Reactor Oversight Process Task Force FAQ Log –
September 16, 2015

FAQ Log for September 16, 2015 ROP Meeting

**NEI 99-02 FAQ 15-02 (Tentative Final)
Prairie Island Power Change December 2014**

NEI 99-02 FAQ 15-03
Unavailability Monitoring of Low-Risk Trains

Figure 1 -- Unit 1 RCS Unidentified Leakage during from 12/03/14 through 12/10/14. Each data point was captured while performing SP 1001AA, Daily Reactor Coolant System Leakage Test. The off-normal condition was first discovered on 11/30/14 (AR 1457811) and the ODMI was signed on 12/9/14.

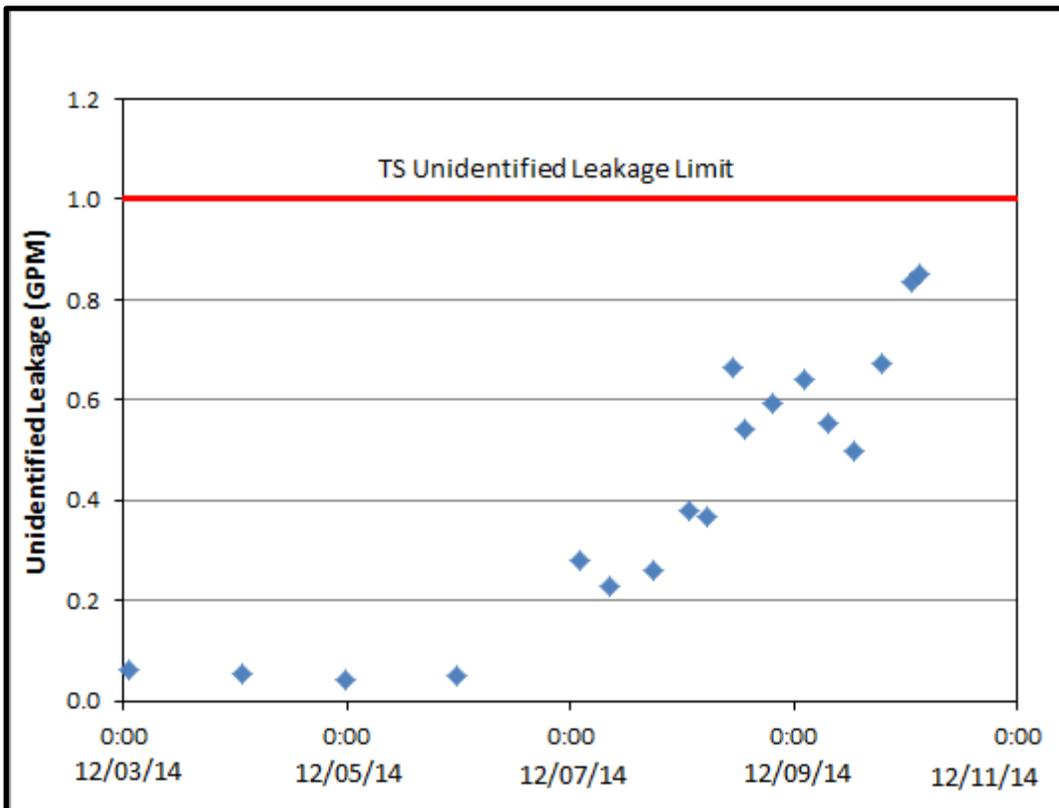
On December 10, 2014, PINGP Unit 1 commenced a power reduction and initiated a forced outage in response to leakage through the 12 Reactor Coolant Pump (RCP) seal. See the timeline below for a description of the actions taken surrounding this event. Figure 1 shows the unidentified leakage rate during the time period of interest.

The NRC Resident agrees with the description of the event. However, it is not clear from NEI 99-02 when the off-normal condition was first discovered and whether the licensee adequately prepared plans to reduce power.

The point of disagreement between the licensee and NRC inspector is on what constitutes “discovery”.

PINGP first identified the slowly degrading off-normal condition under AR 1457811 on 11/30/2014. This was ten days before the Unit 1 shutdown commenced. The ODMI was finalized the day before the

This situation did not degrade beyond predefined limits or require rapid response. Throughout the event, the maximum allowable unidentified leakage of 1.0GPM, as defined in PINGP's Technical Specifications, was not exceeded. The decision to reduce power, aided by guidance in ODMI 1457811, was conservative in nature and provided for a safe transition of the unit to Mode 5. Since normal operating procedures were used to reduce power in Unit 1, a rapid response designated by use of abnormal operating procedure 1C1.4 AOP1, Rapid Power Reduction Unit 1, did not take place.

NEI 99-02 states that "the key element to be used in determining whether a power change should be counted as part of this indicator is the 72-hour period and not the extent of planning that is performed between the discovery of the condition and initiation of the power change." The initiation of AR 1457811 on 11/20/2015 identified the apparent degradation to the reactor coolant pump seal and constitutes "discovery" for the purposes of this indicator. The plant shutdown occurred on 12/10/2015, well in excess of the 72-hour period required prior to the power reduction. Therefore, the power reduction commenced on 12/10/2014 does not count as an Unplanned Power Change per NEI 99-02.

The staff reviewed the licensee's FAQ and the resident inspectors' additional information provided. While the licensee contends that the off-normal condition was first identified on 11/20, the residents' position is that the licensee was unaware of the severity of the condition until it accelerated and a plant shutdown was required on 12/10. NEI 99-02 states "[i]f a condition is identified that is slowly degrading and the licensee prepares plans to reduce power when the condition reaches a predefined limit, and 72 hours have elapsed since the condition was first identified, the power change does not count." In this case the licensee discovered a possible off-normal condition on 11/20, but failed to adequately identify it as a condition that may require a downpower. However, on 12/2, the licensee identified increased RCS unidentified leakage they determined was most likely related to the previously identified condition and requested an ODMI. While the ODMI was not completed until 12/9, the fact that it was requested on 12/2 is the pertinent requirement (ref. FAQ 99-06). The pertinent portion of NEI 99-02 in this case is the excerpt from page 16, lines 40-43:

"If the licensee has previously identified a slowly degraded off-normal condition but has not prepared plans recognizing the potential need to reduce power when the condition reaches predefined limits, then a sudden degradation of that condition requiring rapid response would constitute a new off-normal condition and therefore, a new time of discovery."

In this case, that new time of discovery was on 12/2. As such, it is reasonable to conclude that the licensee determined an off-normal condition that would require a downpower existed on 12/2, well in excess of 72 hours from the subsequent downpower that occurred on 12/10. The staff concludes that this shutdown should not count towards the IE03 PI.
